ADDENDUM NO. 2

NOTICE TO BIDDERS OF PROJECT NO. 20223 RAY WILLIAMSON POOL IMPROVEMENTS – PHASE 1

Bainbridge Island Metro Park & Rec District: Ray Williamson Pool Improvements

CLARIFICATION OF BID QUANTITIES FOR CMU/BRICK RESTORATION RAY WILLIAMSON POOL RENOVATION PHASE 1 8521 MADISON AVENUE N BAINBRIDGE ISLAND, WA 98110	PIC MSL	BID SET PHASE 1 5/8/2024
	PM MSL	SSK 1.2
	DRW	2208

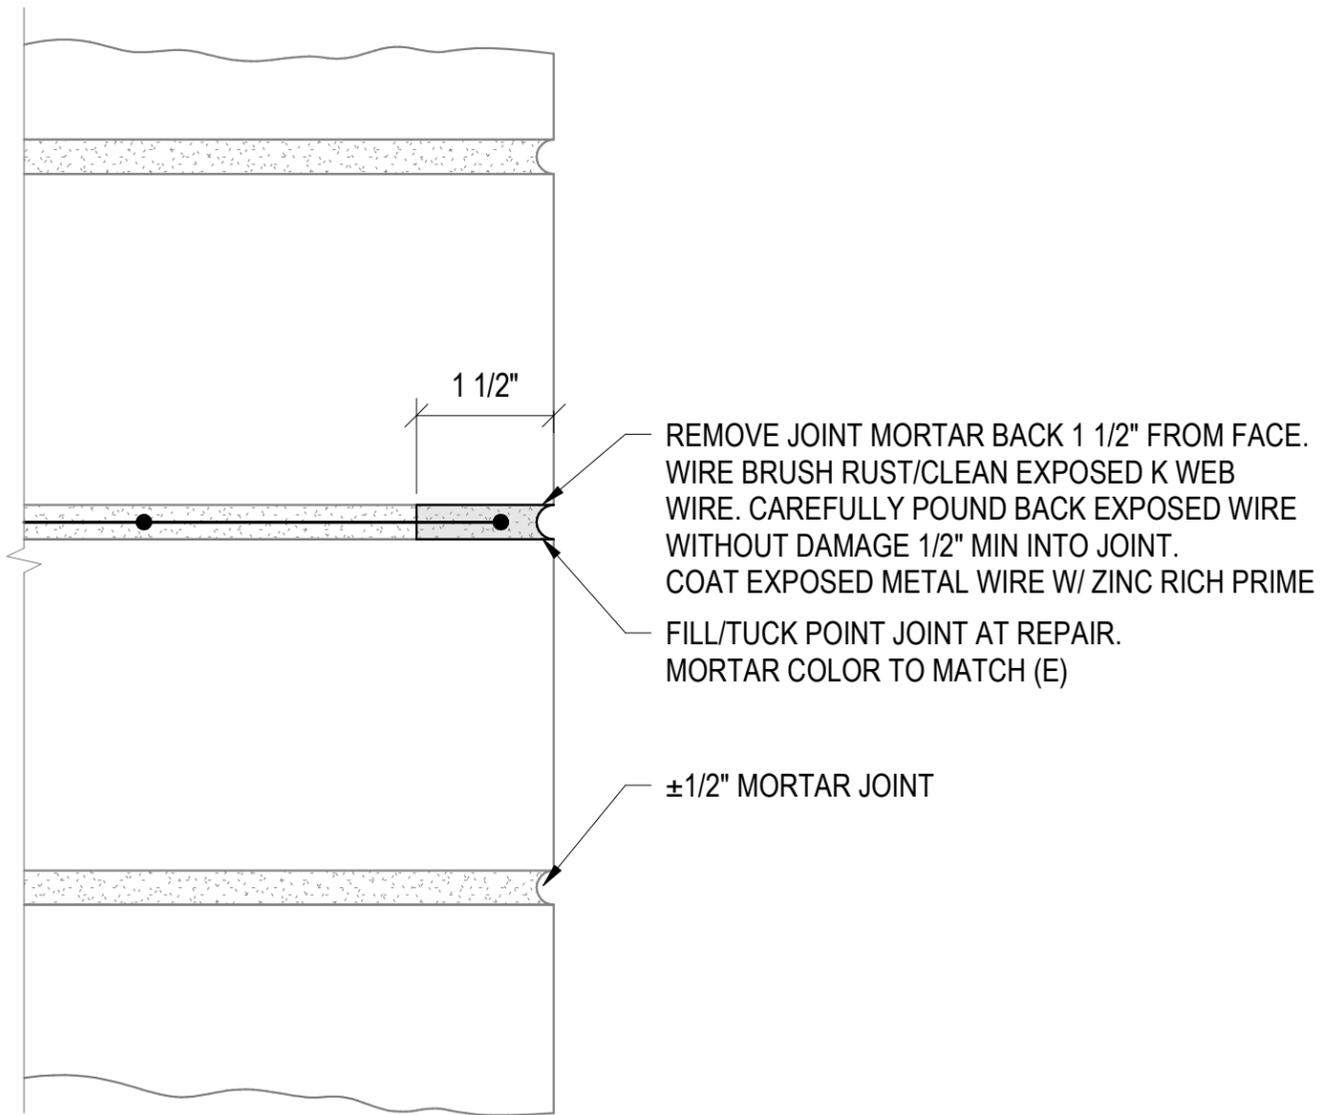
Q4: The areas of repairs for the existing masonry brick are not quantified and several areas are likely unforeseen. How would you like for us to price? We would recommend that the bid form provide a unit price.

DETAIL 7 QUANTITIES: ALLOW FOR RE-POINTING OF 100% OF MORTAR JOINTS AT EXTERIOR & INTERIOR OF BLDG. ALLOW FOR REPAIR OF K-WEB AT EXTERIOR OF BUILDING AS FOLLOWS:

- * WEST ELEVATION: 100%
- * SOUTH ELEVATION: 50% (CONFIRM LOCATIONS WITH PROJ. REP.)
- * EAST ELEVATION: 50% (CONFIRM LOCATIONS WITH PROJ. REP.)

DELETION OF CONCRETE REPAIR WORK FROM PHASE 1 RAY WILLIAMSON POOL RENOVATION PHASE 1 8521 MADISON AVENUE N BAINBRIDGE ISLAND, WA 98110	PIC MSL	BID SET PHASE 1 5/8/2024
	PM MSL	SSK 1.3
	DRW	2208

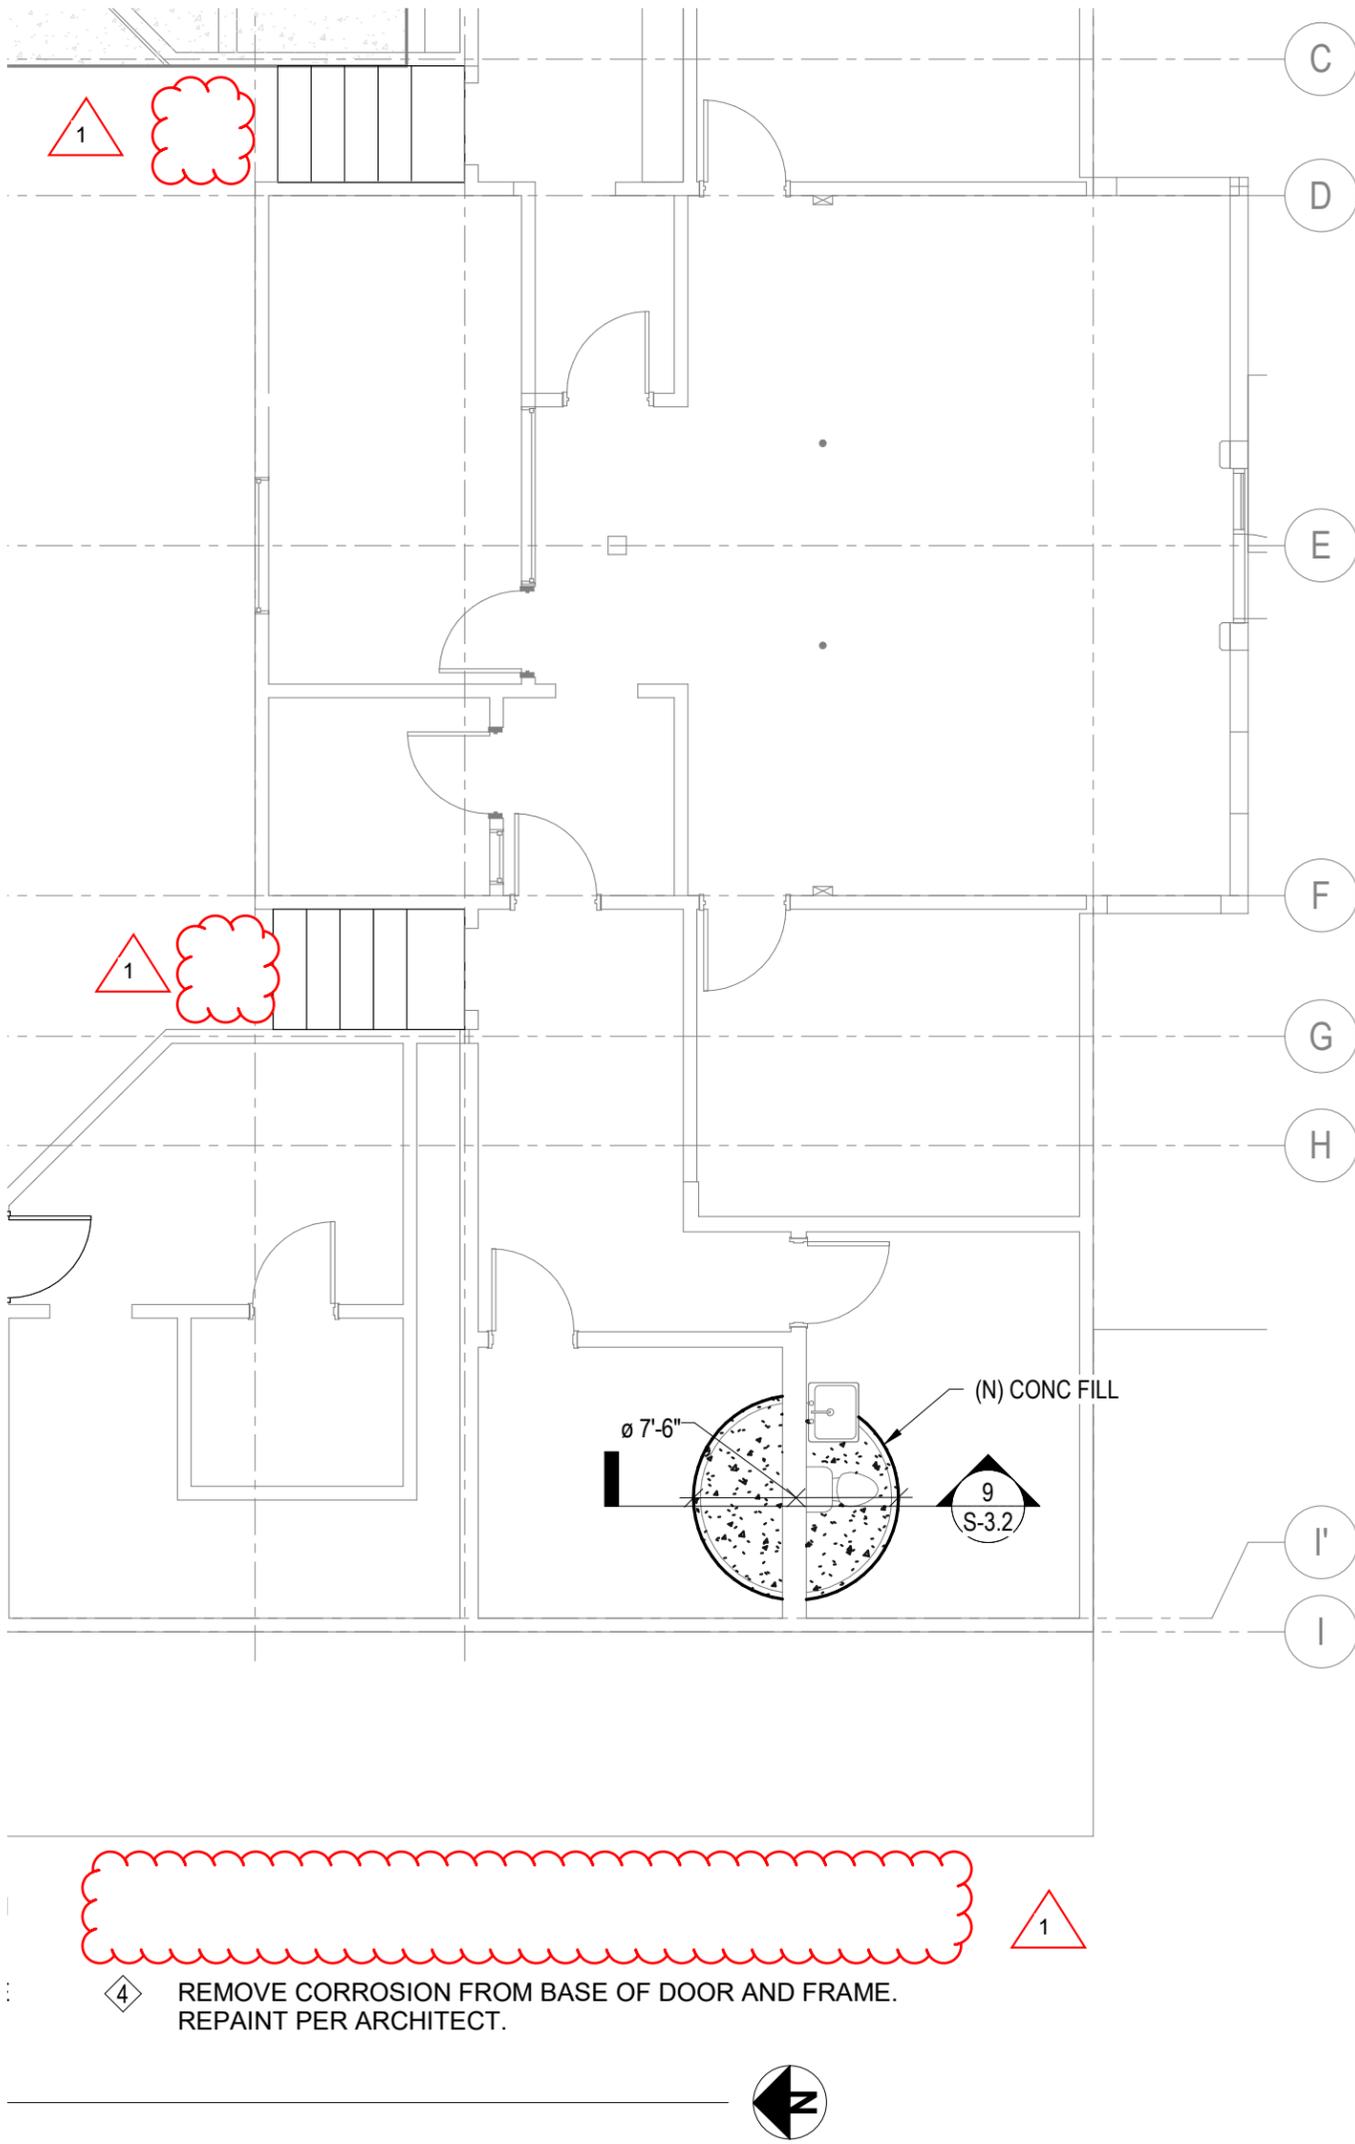
3. Sheet S-1.0 1st Floor Plan

DELETE keynote No.3 EXCAVATE DELAMINATED CONCRETE AND CONCRETE WITH CORRODED REBAR, see SSK-1.3 attached in Addendum No. 2.

FD1.0
2208

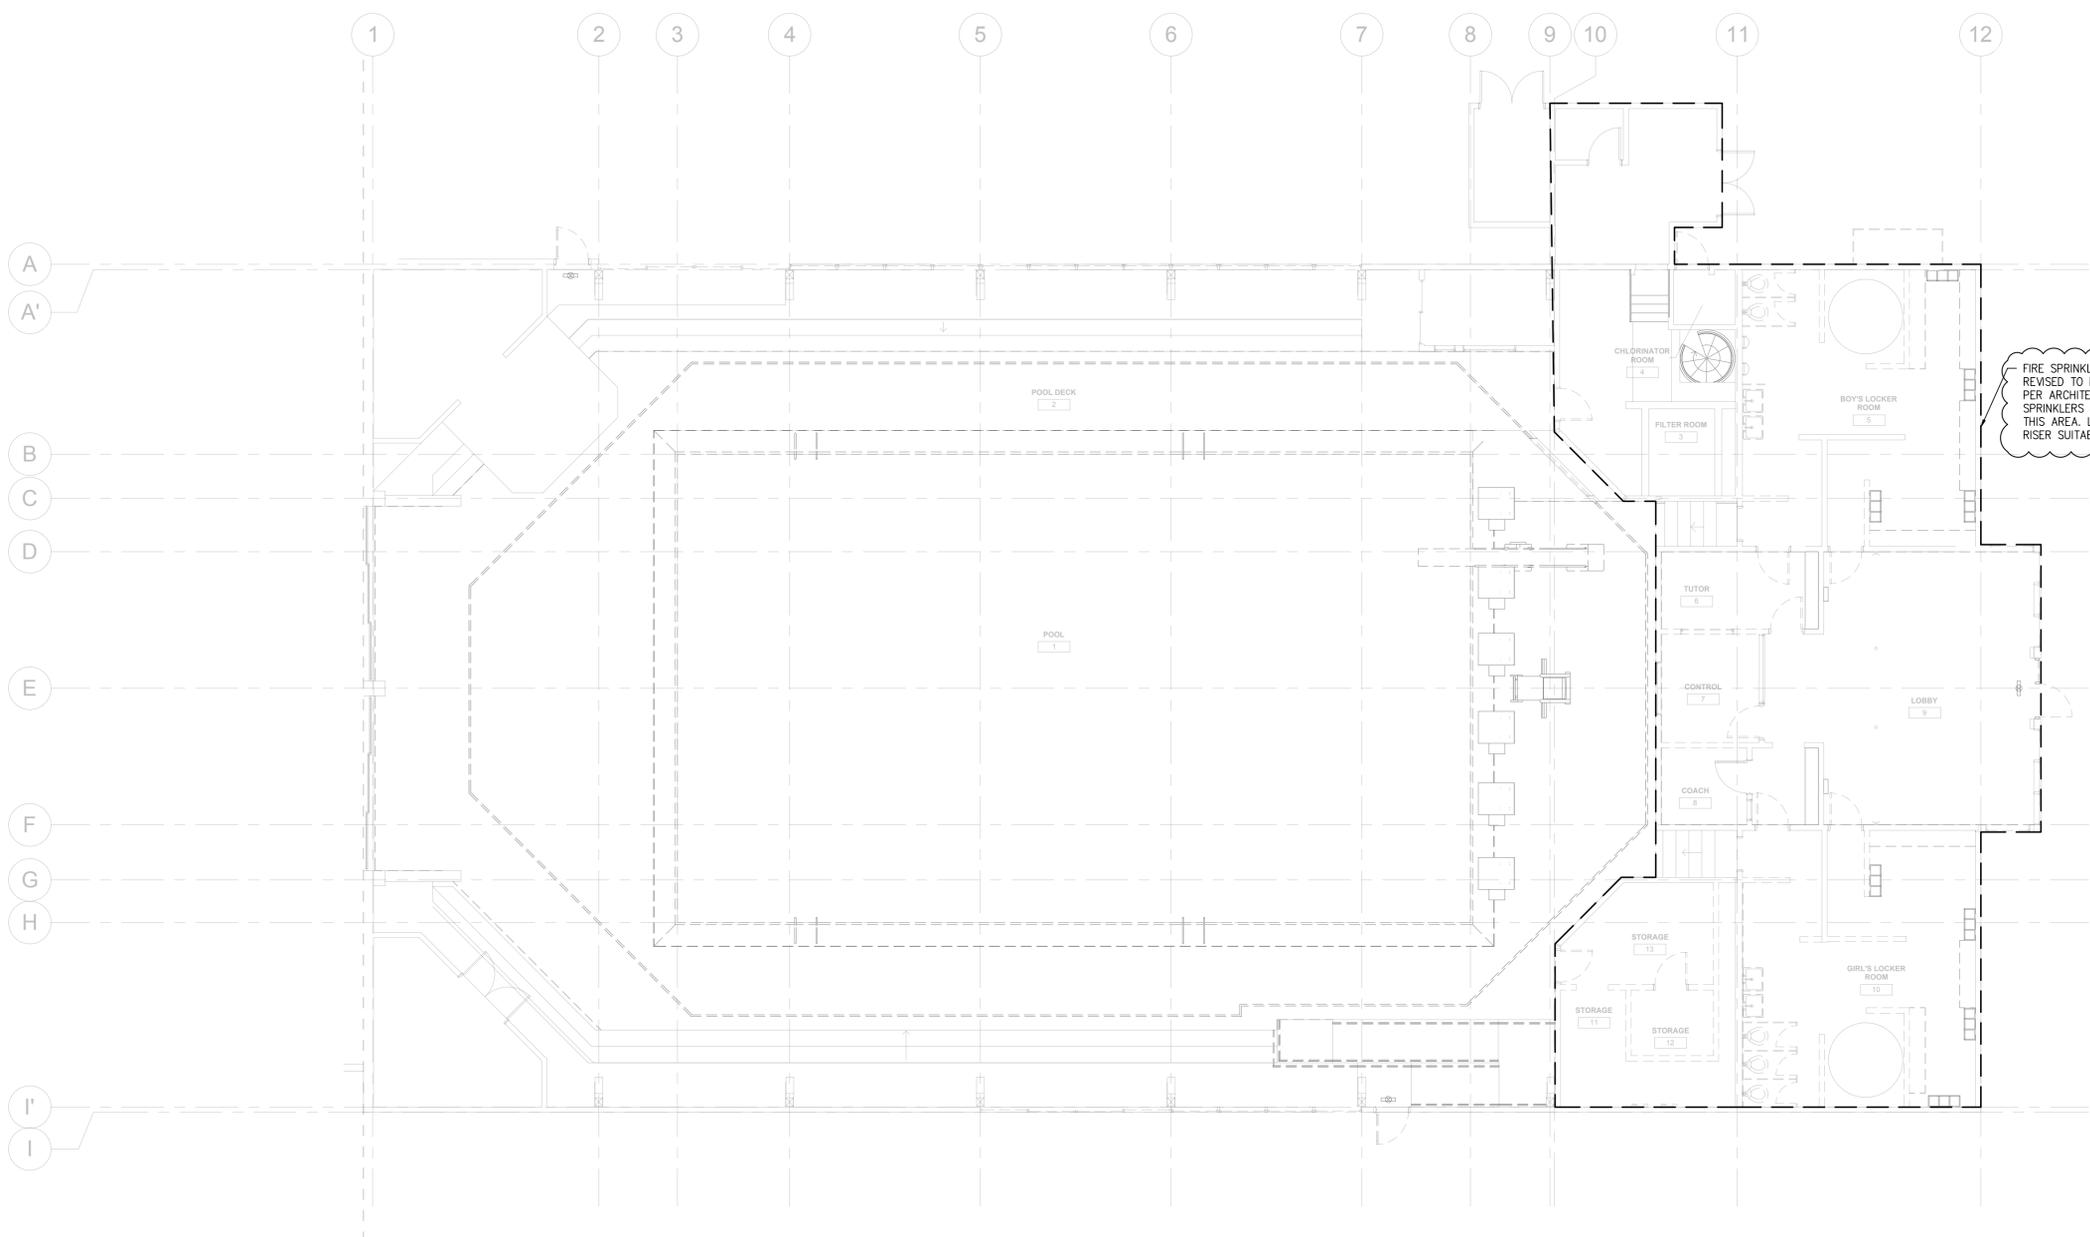
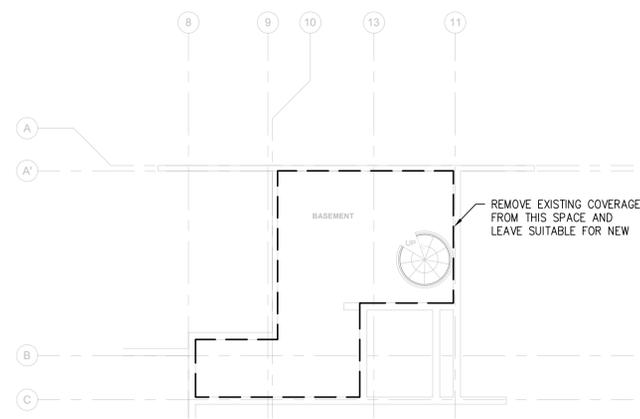
1. **DELETE** sheet FD1.0 First Floor Fire Protection Demolition Plan and **REPLACE** with sheet FD1.0 First Floor Fire Protection Demolition Plan in its entirety, attached in Addendum No. 2.

DELETE plan note on 2/FD1.0 on First Floor Fire Protection Demolition Plan and **REPLACE** with note.

FIRE SPRINKLERS IN THIS AREA TO BE REVISED TO MEET NEW ROOM LAYOUTS PER ARCHITECTURAL. REMOVE ALL SPRINKLERS AND SPRINKLER PIPE IN THIS AREA. LEAVE POC FROM MAIN RISER SUITABLE FOR RE-USE.

Q8: Do we demo out and replace the existing fire sprinkler piping from gridline 9A-I thru 12A-I due to the excessive rust?

A8: ***Demolish existing fire sprinkler pipes and replace as shown on sheet FD1.0 (attached).***

F1.0
2208

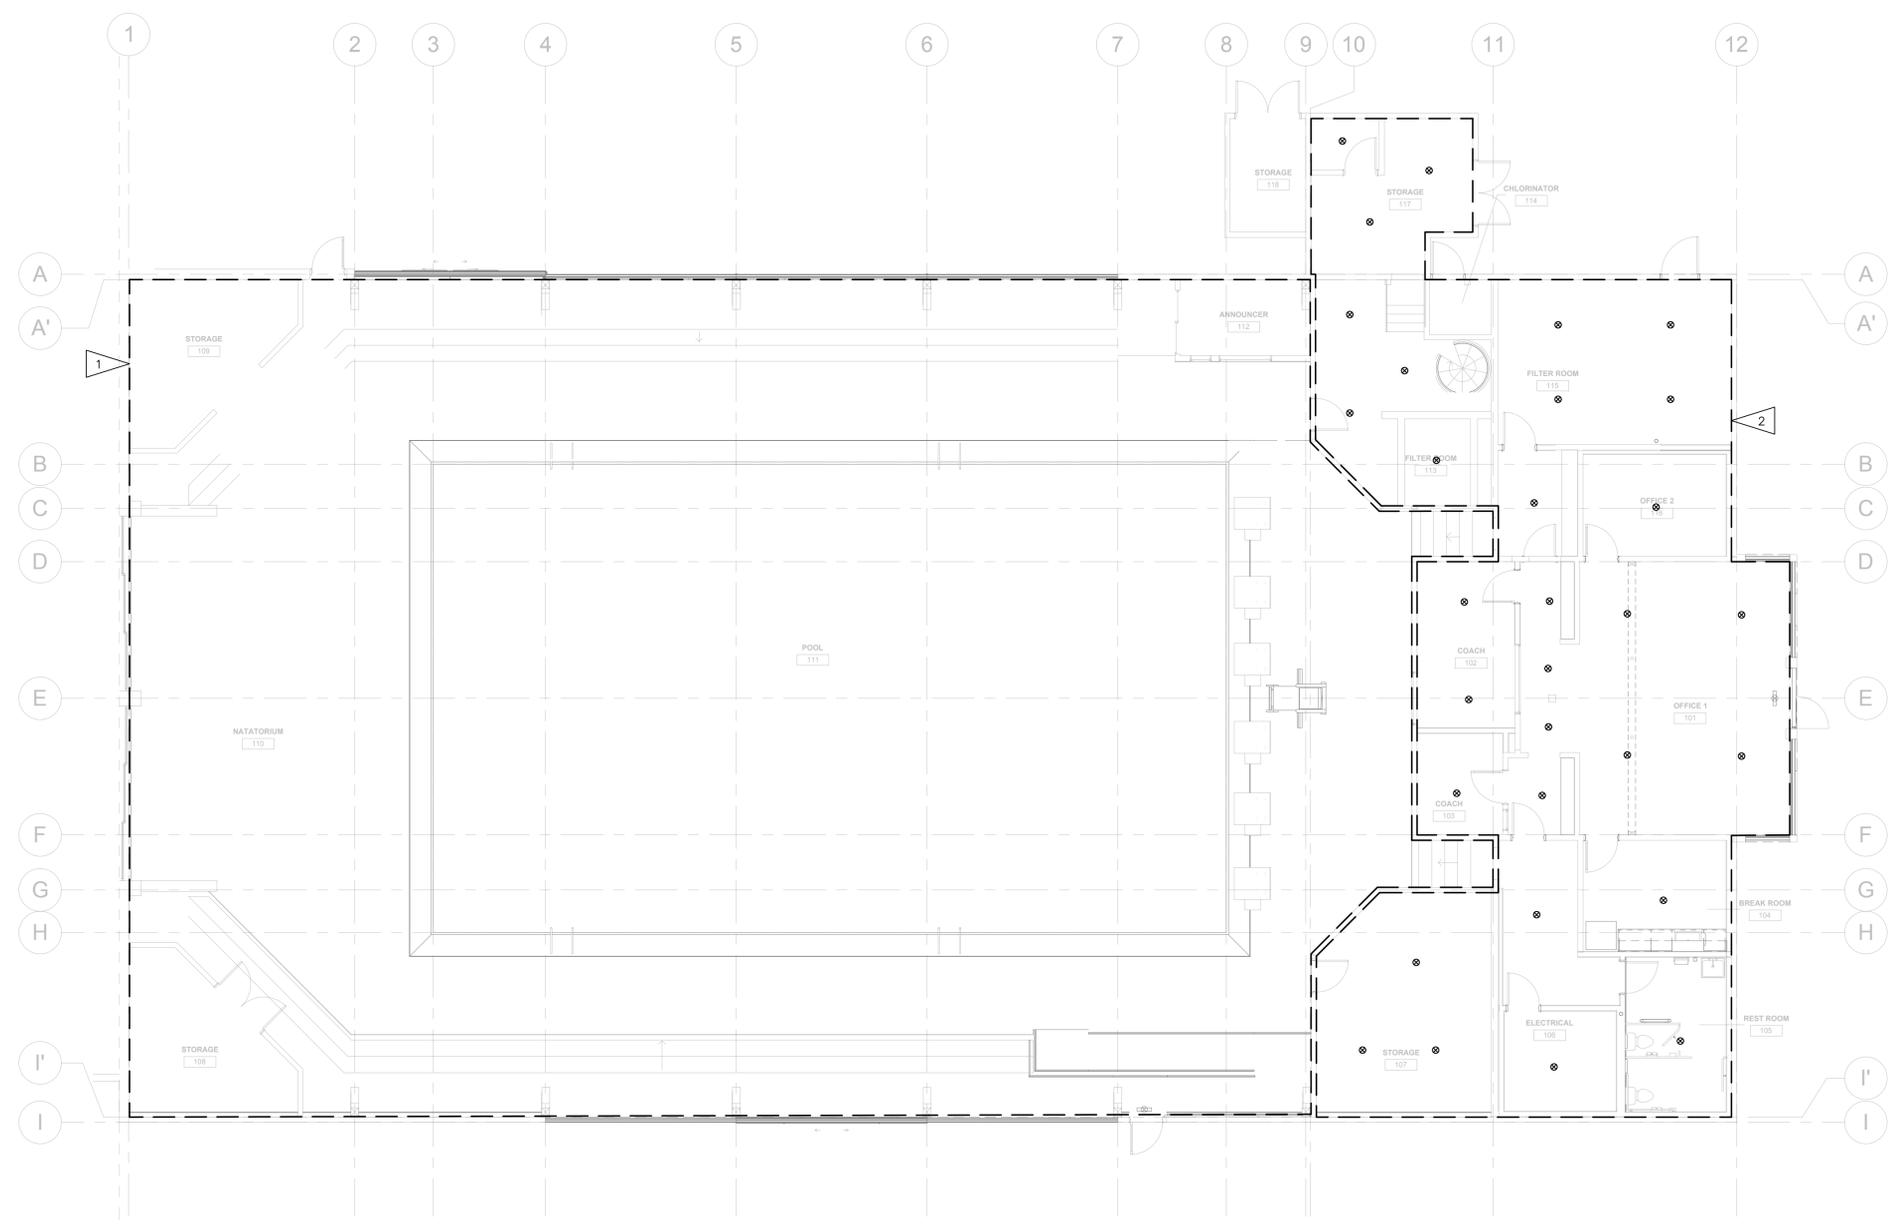
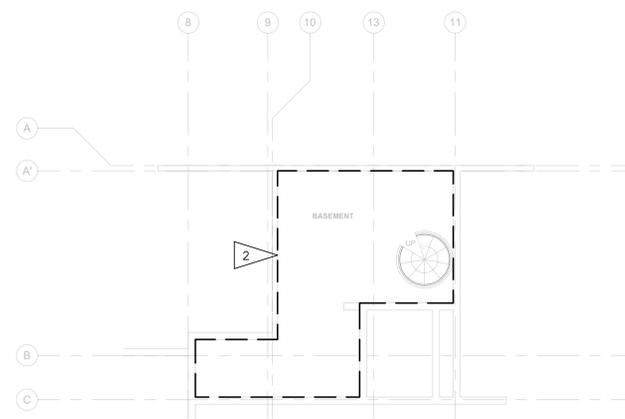
2. **DELETE** sheet F1.0 First Floor Fire Protection Plan and **REPLACE** with sheet F1.0 First Floor Fire Protection Plan in its entirety, attached in Addendum No. 2.

DELETE keynote No. 2 on Sheet Keynotes and **REPLACE** with keynote No. 2.

ALL NEW SPRINKLERS AND SPRINKLER PIPE IN THIS AREA. PAINT FOR CORROSION PROTECTION PRIOR TO COVER.
